UNITED STATES
DEPARTMENT OF THE INTERIOR
BUREAU OF LAND MANAGEMENT
SUNDRY NOTICES AND REPORTS ON WELLS

Condor 8 Federal Com 2H

Devon Energy Production Company, LP respectfully requests approval of the Rig layout, BOP language, and pilot hole changes from our original APD.

CONDITIONS OF APPROVAL

11" x 5,000 psi BOP Stack

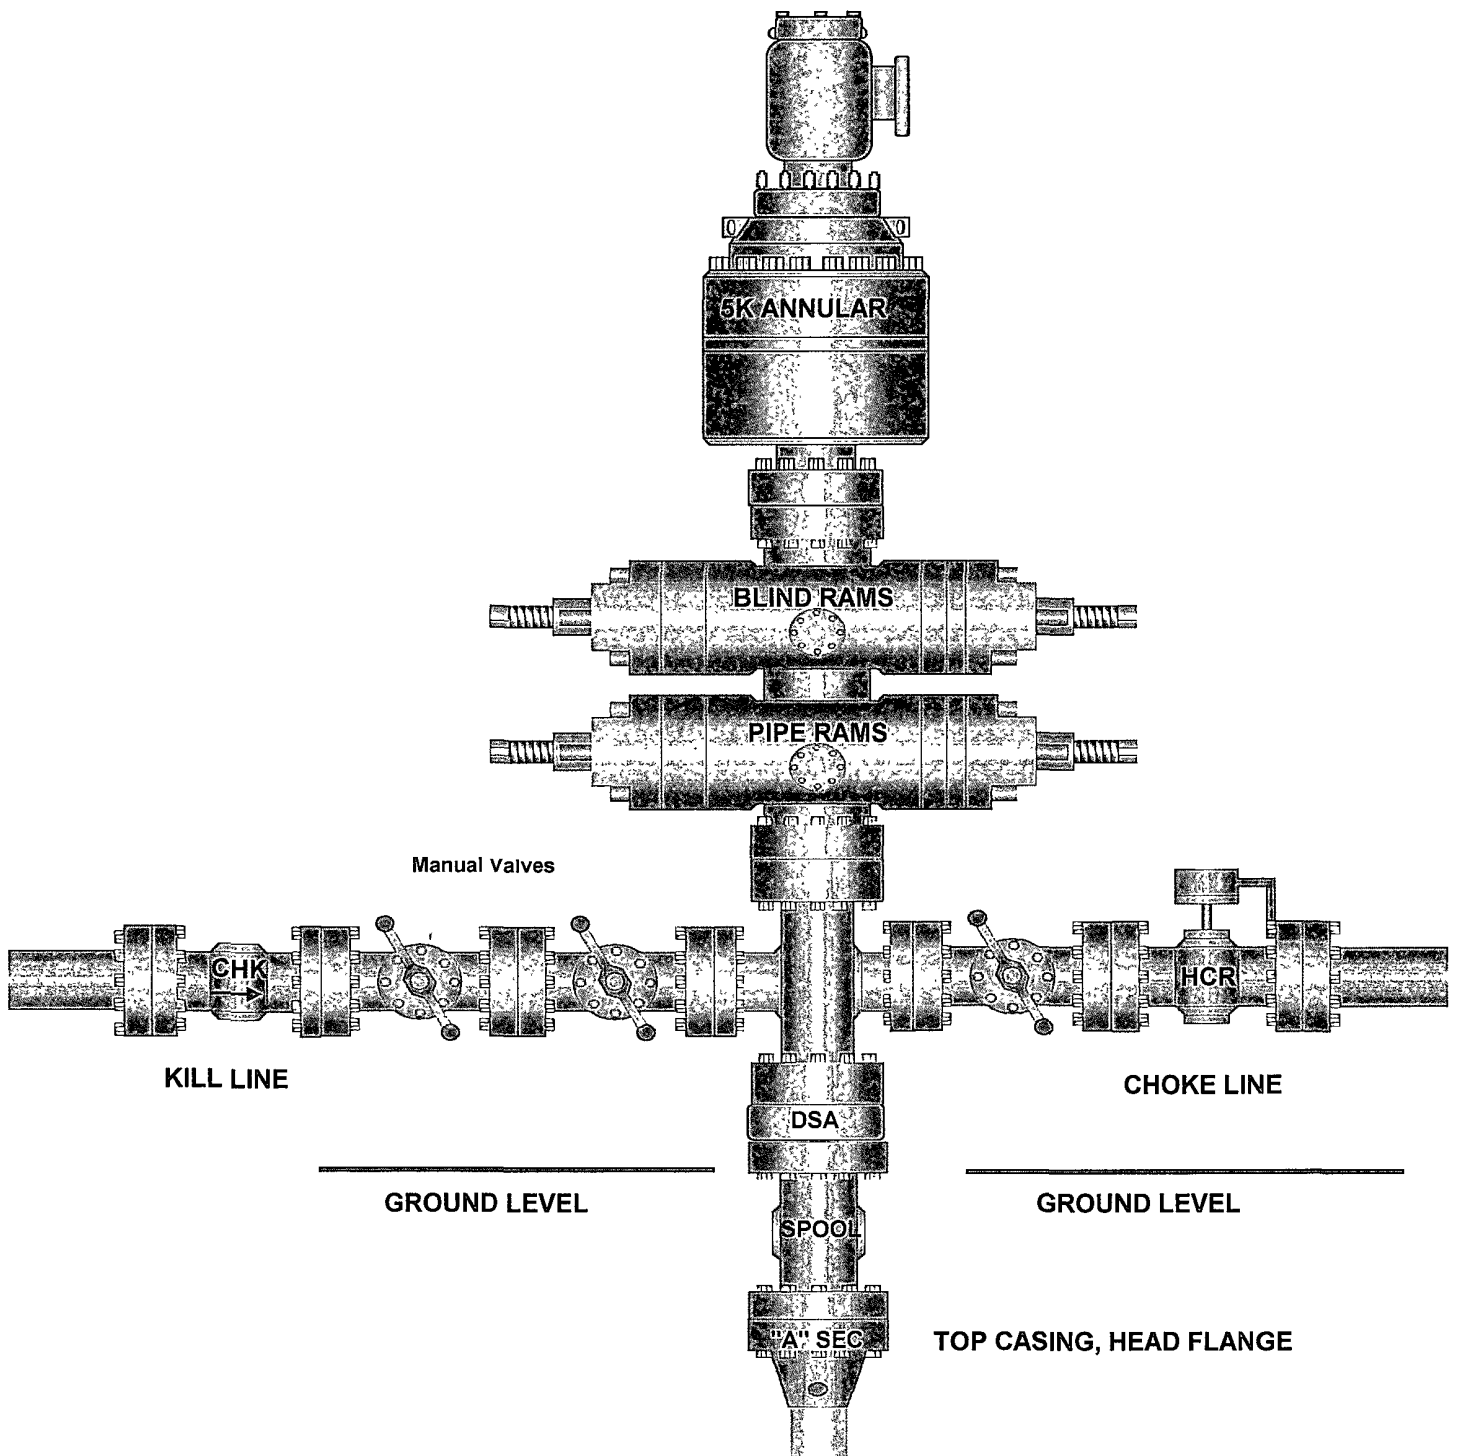
Rig Change to Patterson 41 (see attached rig layout and BOP schematic).

The BOP system used to drill the intermediate hole will consist of an 11" 5M Double Ram and Annular preventer. The BOP system will be tested as per BLM Onshore Oil and Gas Order No. 2 as a 3M system prior to drilling out the surface casing shoe.

The BOP system used to drill the production hole will consist of an 11" 5M Double Ram and Annular preventer. The BOP system will be tested as per BLM Onshore Oil and Gas Order No. 2 as a 5M system prior to drilling out the intermediate casing shoe.

The pipe rams will be operated and checked each 24 hour period and each time the drill pipe is out of the hole. These tests will be logged in the daily driller's log. A 2" kill line and 3" choke line will be incorporated into the drilling spool below the ram BOP. In addition to the rams and annular preventer, additional BOP accessories include a kelly cock, floor safety valve, choke lines, and choke manifold rated at 5,000 psi WP.

1. All blowout preventer (BOP) and related equipment (BOPE) shall comply with well control requirements as described in Onshore Oil and Gas Order No. 2 and API RP 53 Sec. 17.
2. Minimum working pressure of the blowout preventer (BOP) and related equipment (BOPE) required for drilling below the surface casing shoe shall be **3000 (3M) psi. The operator is using a 5M, but testing as a 3M.**

3. Minimum working pressure of the blowout preventer (BOP) and related equipment (BOPE) required for drilling below the 7 inch intermediate casing shoe shall be **5000 (5M) psi. 5M system requires an HCR valve, remote kill line and annular to match. The remote kill line is to be installed prior to testing the system and tested to stack pressure.**
